## Human Factors Engineering Assessment of the Mini-Flail System

ARL-TN-79

NOVEMBER 1996

A human factors engineering (HFE) assessment was conducted on the mini-flail system whose basic mission is to neutralize anti-personnel hazards. The assessment revealed numerous HFE design problem areas. Recommendations for design modifications to fulfill the military standard requirements are discussed.

Figure 2. The mini-flail wireless remote.

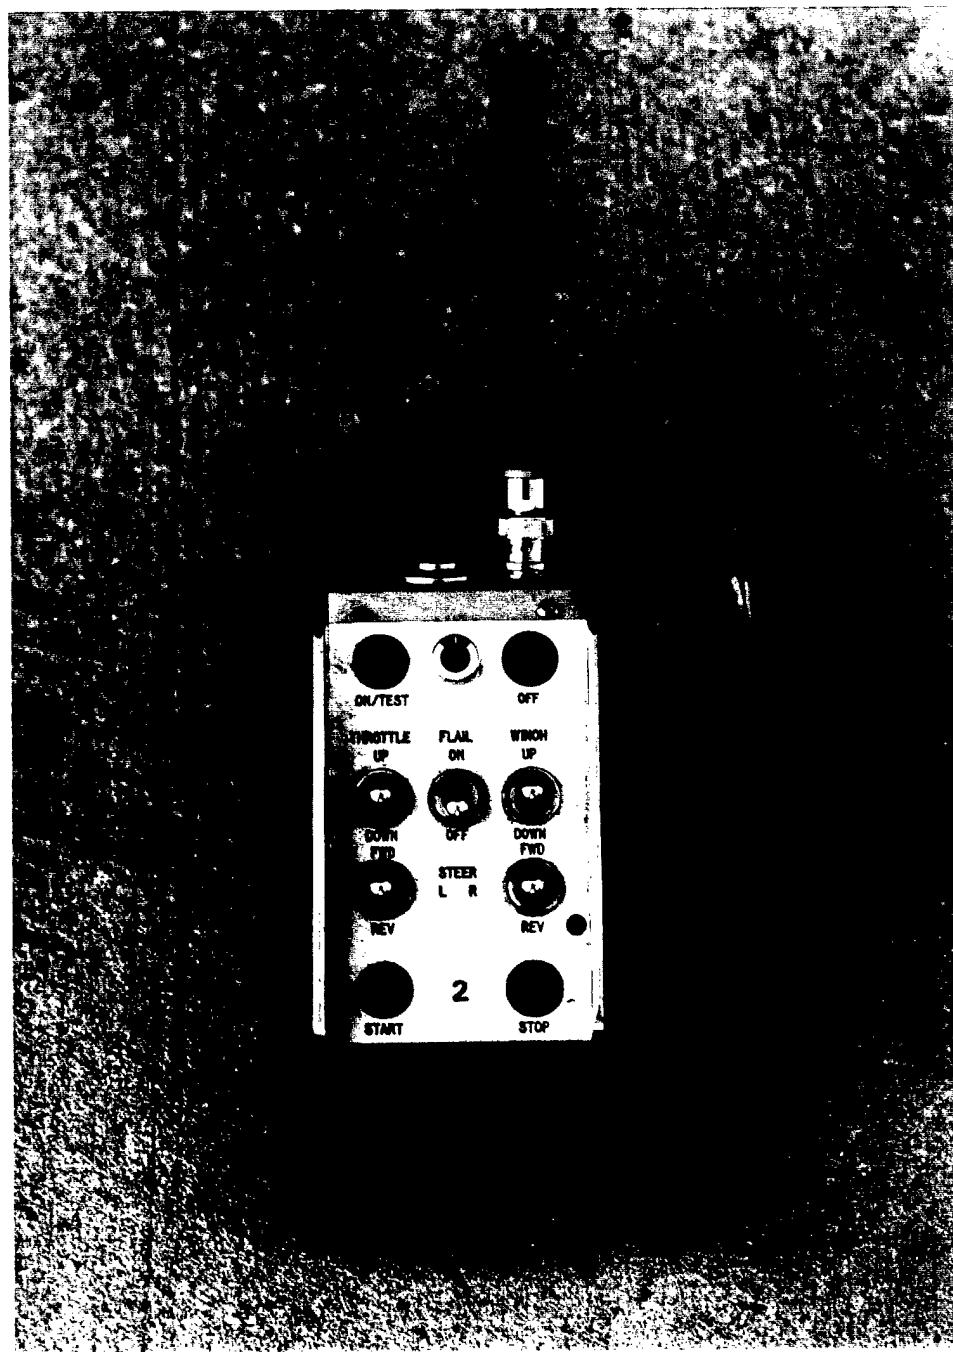
The mini-flail remote (see Figure 2) control and display measurements and minimum requirements are provided in Table 1. Physical measurements were not made of the few controls on the mini-flail since the human factors specialist did not deem it necessary after cursory examination.

- (1) The red push button on top of the wireless remote used to begin flailing operations was not labeled. This push button acts as a secondary sequential control for flailing to limit accidental actuation of the flail toggle switch between the throttle and winch toggle switches.
- (2) The battery meter, located on the remote face (center, first row), was not labeled.

(1) Labels, legends, placards, signs, or markings shall be provided whenever it is necessary for personnel to identify, interpret, follow procedures, or avoid hazards, except when it is obvious to the user what an item is and how it is to be used, in accordance with MIL-STD-1472D, paragraph 5.5.1.1. The red push button on top of the remote, used to begin flailing action should be properly labeled.

(2) The battery meter should be labeled in accordance with MIL-STD-1472D, paragraph 5.5.1.1.

(11) The remote control should possess more descriptive labeling for its controls. The "on/test" push button should read, "remote on/test" and the "off" push button should read, "remote off." The "start" push button should read, "engine start" and the "stop" push button should read "engine stop."

(12) It is recommended that a continuous, automatic display be provided to show battery power status in order to eliminate the need for the user to monitor power by pressing the on/test push button.

Figure 3. Controls on the exterior rear panel of the mini-flail (either not labeled or labeled inadequately).

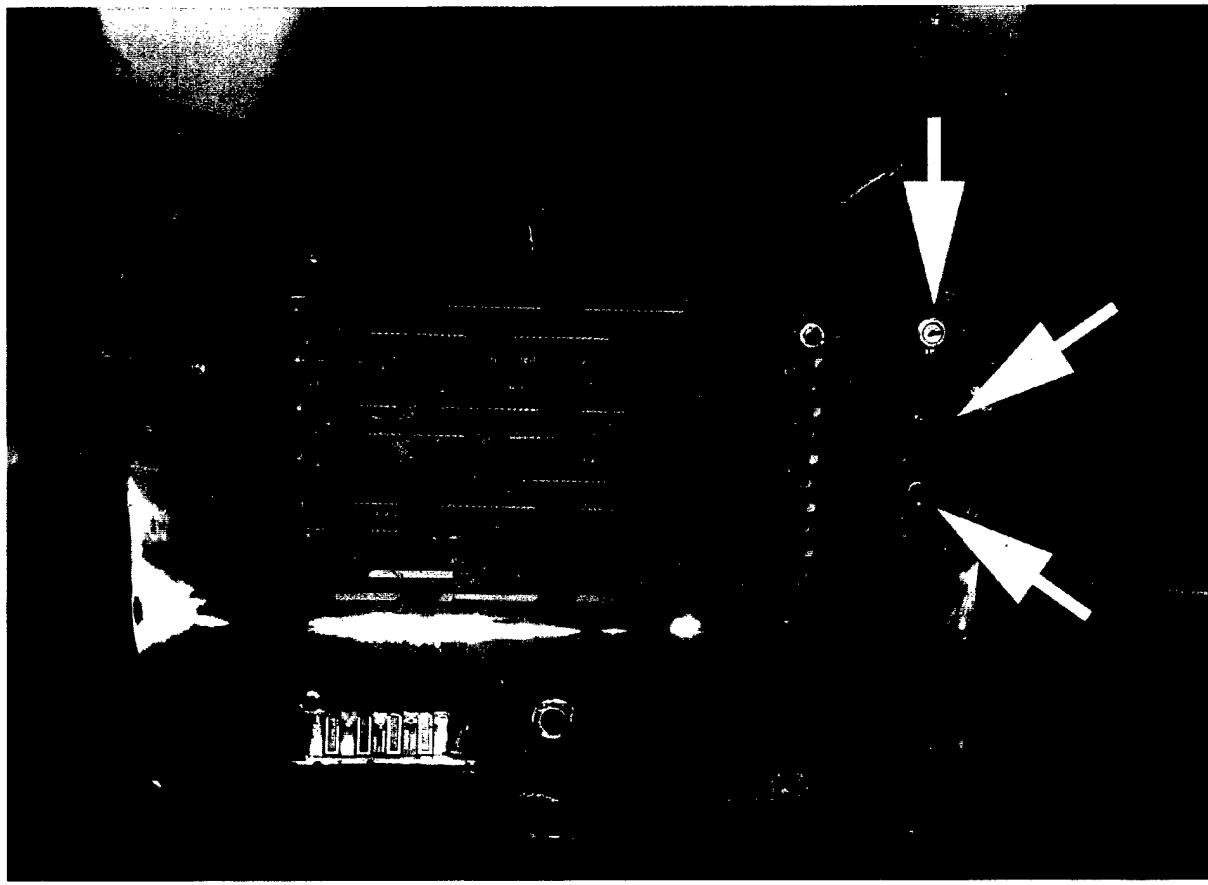
(3) All controls on the rear of the mini-flail, including the emergency stop push button, two toggle switches, and ignition, were either not labeled or labeled inappropriately (see Figure 3).

(13) The “off” and “on” positions of the toggle on the exterior rear panel of the mini-flail are incorrect.

(3) The emergency stop push button, two toggle switches, and ignition should be labeled in accordance with MIL-STD-1472D, paragraph 5.5.1.1. Labels shall be clear, distinct, have high contrast, be mounted so as to minimize wear or obscurement by grease, grime, or dirt, and remain legible for the overhaul interval of the item on which they are mounted in accordance with MIL-STD-1472D, paragraph 5.5.4.5.

(13) The "off" and "on" operational positions of the toggle switch located on the exterior rear panel of the Mini-flail need to be corrected so that "off" is the left position and "on" is the right position. Generally, control movement forward, clockwise, to the right, or up, or pressing a control shall turn the equipment or component on, cause quantity to increase, or cause forward, clockwise, to the right, or upward movement in accordance with MIL-STD-1472D, paragraph 5.4.1.2.1. Labeling should then be modified to correspond with the appropriate operational positions.

Figure 4. The junction box labels (should be permanent, and the lettering should be oriented horizontally).

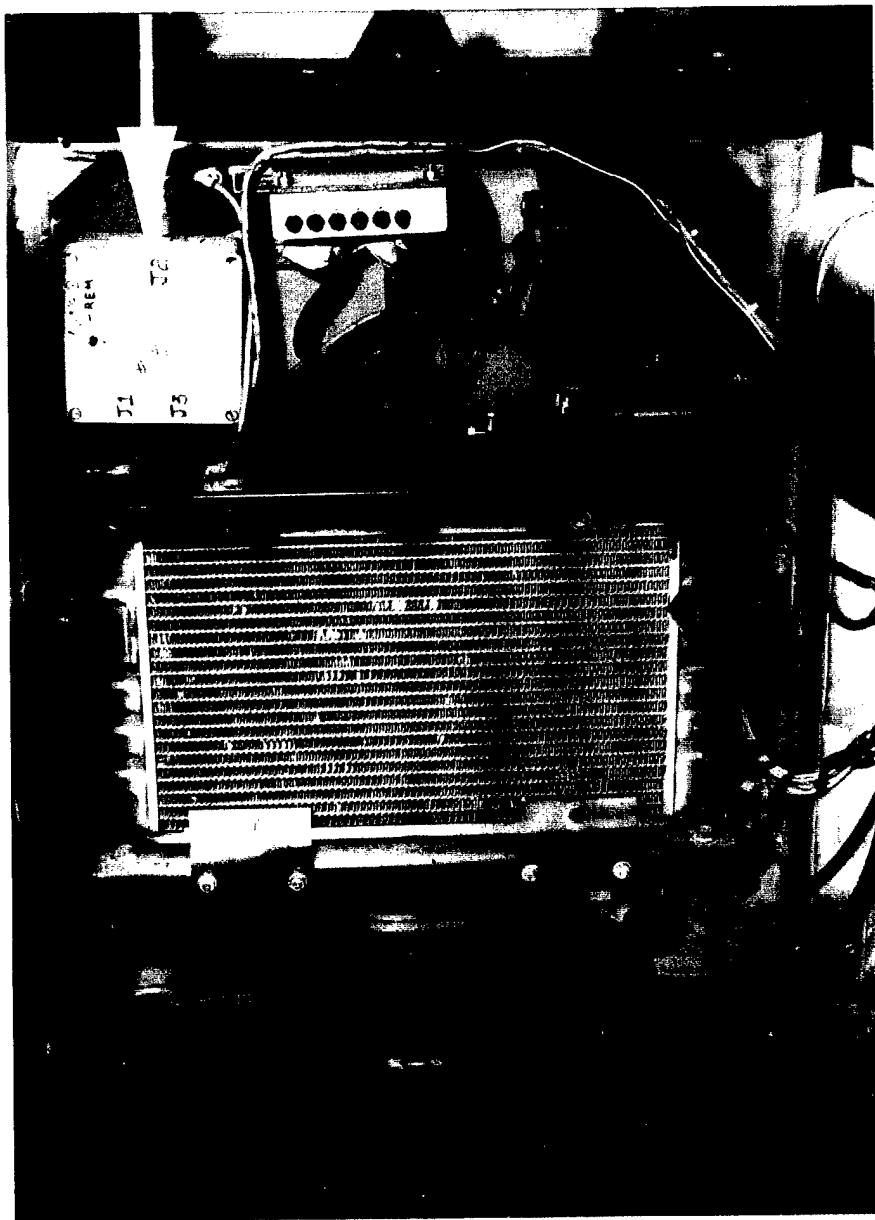
- (12) There was no automatic battery power indicator.
- (13) There were no nonskid surfaces for stepping on the hood.
- (14) The junction box possessed only temporary labeling that was not horizontally oriented (letters positioned for reading from left to right) (see Figure 4).
- (15) Cables on the interior housing lacked adequate labeling.

(14) The junction box labeling needs to be made permanent in accordance with MIL-STD-1472D, paragraph 5.5.4.5. Letter orientation should be horizontal so that the letters may be read quickly and easily from left to right in accordance with MIL-STD-1472D, paragraph 5.5.2.1.

Figure 5. The two exterior springs, two interior shocks, and support rod, critical for sustaining the hood in the opened position.

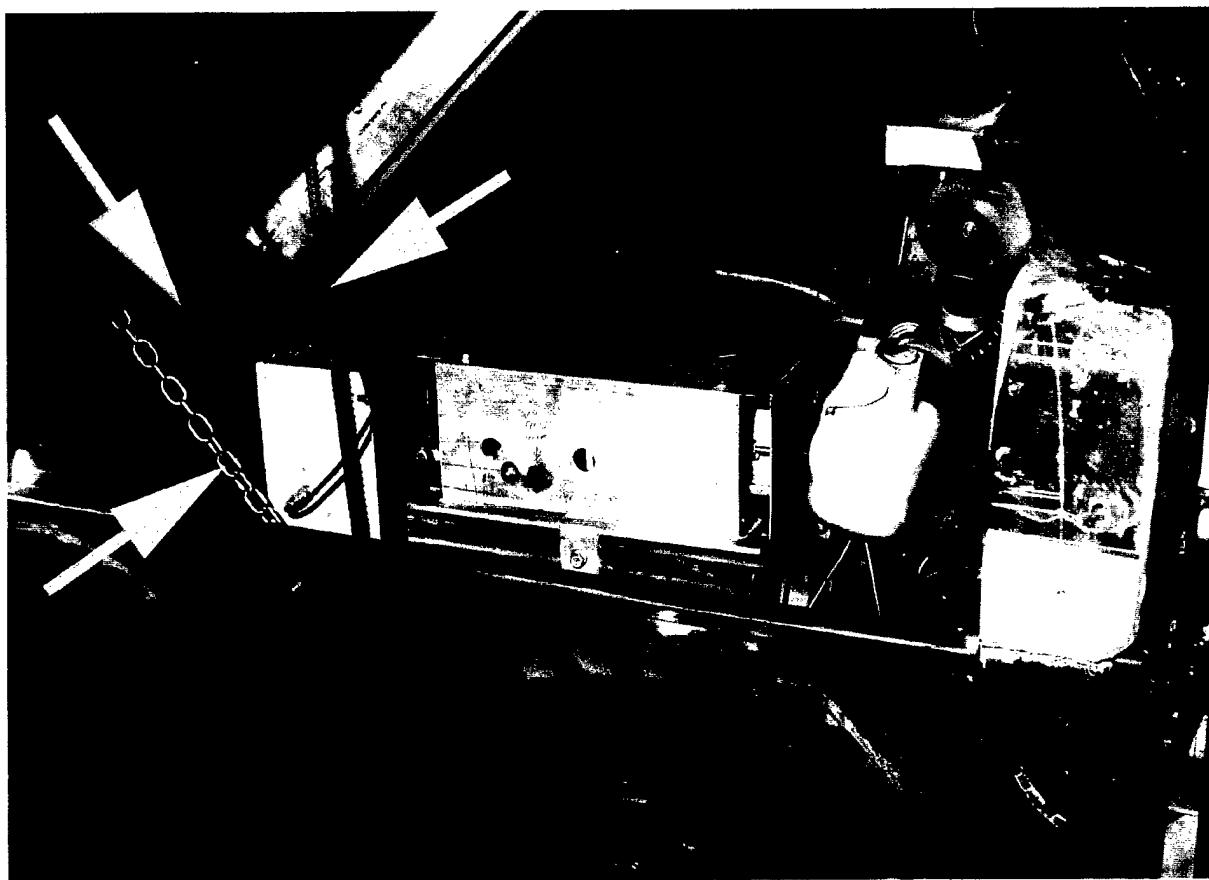
(8) The mini-flail hood weighs approximately 300 lb. The hood can cause critical injury to personnel if the support rod is not put in place after being opened. The two exterior springs, two interior shocks, and support rod (see Figure 5) are critical elements for sustaining the hood in an opened position for preventive maintenance, checks, and services (PMCS) and other service required by the system.

- (8) Labeling and manual notation should be made to warn the user of potential critical injury from the heavy hood if the exterior springs, two interior shocks, and support rod are not in place and functional in accordance with MIL-STD-1472D, paragraph 5.13.2.1. High wind may cause the hood to close or cause the mini-flail to flip forward during maintenance procedures.

Figure 6. The flail head in motion.

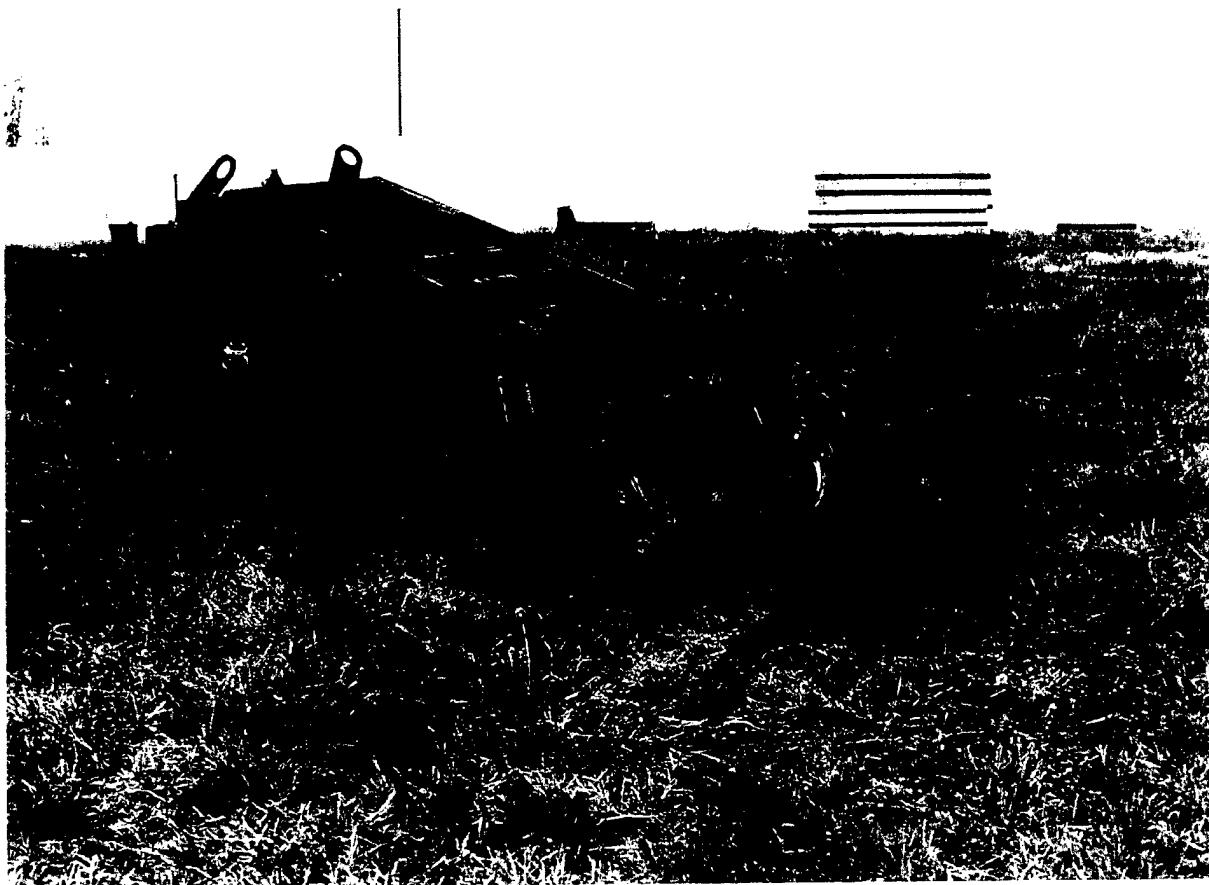
- (7) The mini-flail hood had no warning or caution labels to make personnel aware of potential crushing hazards.
- (8) The mini-flail possessed no warning to personnel of needed clearances during flailing and sweeping operations.
- (9) The emergency stop push button on the remote was difficult to locate quickly since there were three red push buttons. The secondary flail push button, located atop the remote, the "off" push button, and the "stop" push button were all red.
- (10) No instruction plate existed.
- (11) The remote lacked needed descriptive labeling for some of its controls.

(8) The mini-flail should possess warning labels to make personnel aware of the needed clearances during flailing and sweeping operations (see Figure 6) in accordance with MIL-STD-1472D, paragraph 5.13.2.1.

Figure 7. The carriage that houses the chain (this should be modified to prevent the chain from becoming entangled).

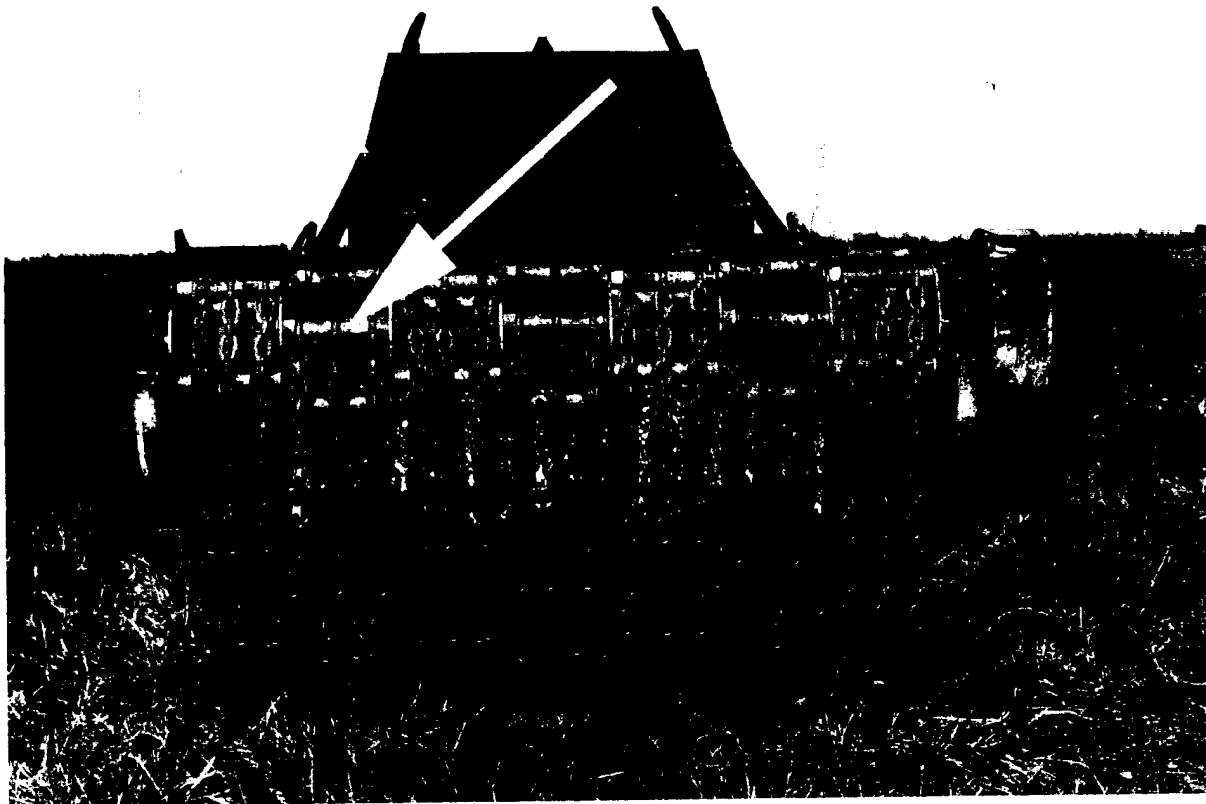
(11) During flailing and sweeping actions, chains become entangled.

- (11) The carriage housing the chains should be modified to prevent the chains from becoming entangled (see Figure 7). It is recommended that the instruction manual and plate warn personnel that the flail chains become entangled and must be manually untangled after use.
